# Access Compliance Report

## Public Rights-of-Way

### (Curb Ramps)

Intersection ID: 6401	Main Street: MURPHY_HILL_PL	Cross Street: STINSON_GLEN_LN	Location: E
ADA ID: D5A4DD663292	Ramp Type: BlendTrans1	Initial Pass/Fail: Fail	Overall Compliance: No
		Severity Score: 25

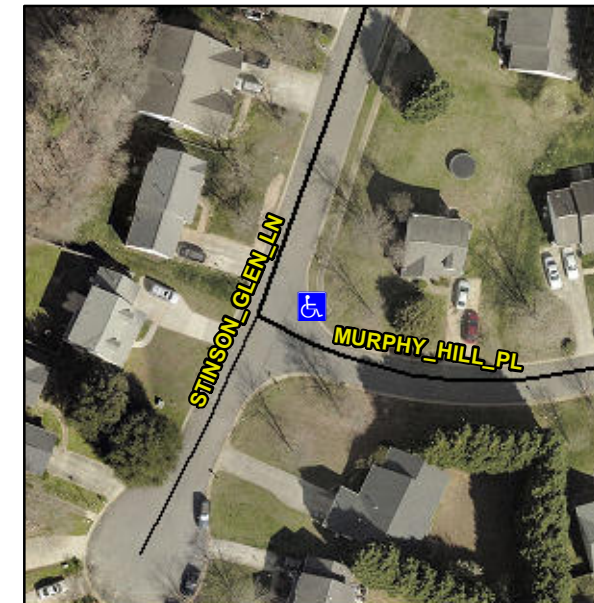
**NO RT SW**

**Not Found, R304.5.3**

Compliance	Description	Data	Compliance	Description	Data
N/A	Ramp Length (in)	48.0	Yes	BlendTrans Slope (%)	2.1
Yes	Ramp Width (in)	48.0	No	BlendTrans XSlope (%)	9.8
N/A	Flare Type LT	N/A	N/A	Flare Type RT	N/A
N/A	Flare Slope LT (%)	N/A	N/A	Flare Slope RT (%)	N/A
N/A	Flare Traversable LT?	N/A	N/A	Flare Traversable RT?	N/A
N/A	Landing Length (in)	N/A	N/A	DWS Provided?	N/A
N/A	Landing Width (in)	N/A	N/A	DWS Contrast?	N/A
N/A	Landing Slope (%)	N/A	N/A	DWS Length (in)	N/A
N/A	Landing X Slope (%)	N/A	N/A	DWS Full Width?	N/A
N/A	Landing Curb? (Y/N)	N/A	N/A	DWS Offset (in)	N/A
N/A	Shared Landing?	N/A			
N/A	Gutter Ponding?	N/A	N/A	Gutter Slope (%)	N/A
N/A	Gutter Lip Ht (in)	N/A	N/A	Gutter X Slope (%)	N/A
N/A	Painted X Walk1?	No	N/A	Painted X Walk2?	No
	X Walk 1 Direction	To W		X Walk 2 Direction	To S
	X Walk 1 Width (in)	N/A		X Walk 2 Width (in)	N/A
	X Walk 1 Slope (%)	0.7		X Walk 2 Slope (%)	N/A
	X Walk 1 X Slope (%)	6.7		X Walk 2 X Slope (%)	N/A

N/A	Ramp inside XWalk1?	N/A	N/A	Ramp inside XWalk2?	N/A
	Road Slope (%)	6.7		Clear Space?	N/A
	Road X Slope (%)	0.7	N/A	Clear Space to XWalk (in)	N/A
N/A	Any Obstructions?	N/A	N/A	Storm Grate/Utility Hazard?	N/A
	Obstruction Type			Storm Grate/Utility Type	
		N/A			N/A
			Yes	Surface Condition? (G/P)	Good
			No	Curb Slope (%)	5.3

**Remove & Replace Curb Ramp With Two New Directional Ramps or Equivalent.**
